Access Compliance Report

(Curb Ramps)

Intersection ID: 53088	Main Street: KENMERE_LN	Cross Street: DEERFIELD_MANOR_DR	Location: NE
ADA ID: 2328DBDDE11C	Ramp Type: Perp	Initial Pass/Fail: Fail	Overall Compliance: No
Severity Score: 25			
Codes/Mitigation Info/Possible Solution		Field Measurements/Component Compliance

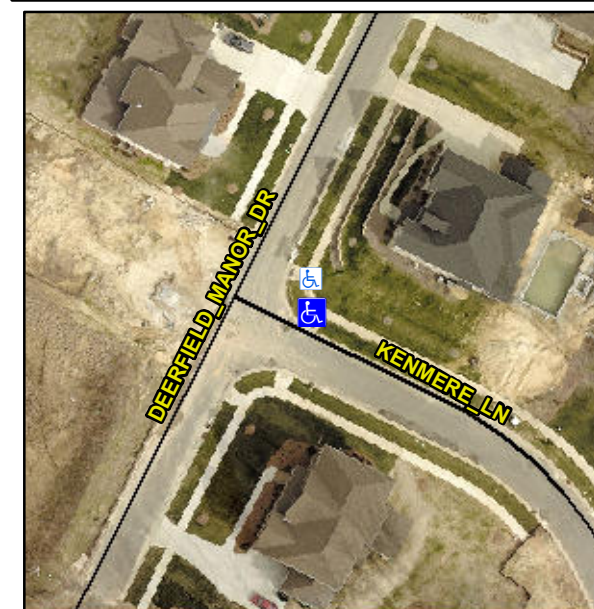
Surveyor Notes:

Compliance	Description	Data	Compliance	Description	Data
N/A	Ramp Length (in)	106.0	No	Ramp Slope (%)	13.4
Yes	Ramp Width (in)	48.0	Yes	Ramp XSlope (%)	0.5
N/A	Flare Type LT	N/A	N/A	Flare Type RT	N/A
N/A	Flare Slope LT (%)	N/A	N/A	Flare Slope RT (%)	N/A
N/A	Flare Traversable LT?	N/A	N/A	Flare Traversable RT?	N/A
N/A	Landing Length (in)	N/A	N/A	DWS Provided?	N/A
N/A	Landing Width (in)	N/A	N/A	DWS Contrast?	N/A
N/A	Landing Slope (%)	N/A	N/A	DWS Length (in)	N/A
N/A	Landing X Slope (%)	N/A	N/A	DWS Full Width?	N/A
N/A	Landing Curb? (Y/N)	N/A	N/A	DWS Offset (in)	N/A
N/A	Shared Landing?	N/A			
N/A	Gutter Ponding?	N/A	N/A	Gutter Slope (%)	N/A
N/A	Gutter Lip Ht (in)	N/A	N/A	Gutter X Slope (%)	N/A
N/A	Painted X Walk1?	No	N/A	Painted X Walk2?	N/A
	X Walk 1 Direction	To SW		X Walk 2 Direction	N/A
N/A	X Walk 1 Width (in)	N/A	N/A	X Walk 2 Width (in)	N/A
	X Walk 1 Slope (%)	2.3		X Walk 2 Slope (%)	N/A
	X Walk 1 X Slope (%)	3.0		X Walk 2 X Slope (%)	N/A

Remove & Replace Entire Ramp.

R304.2.2
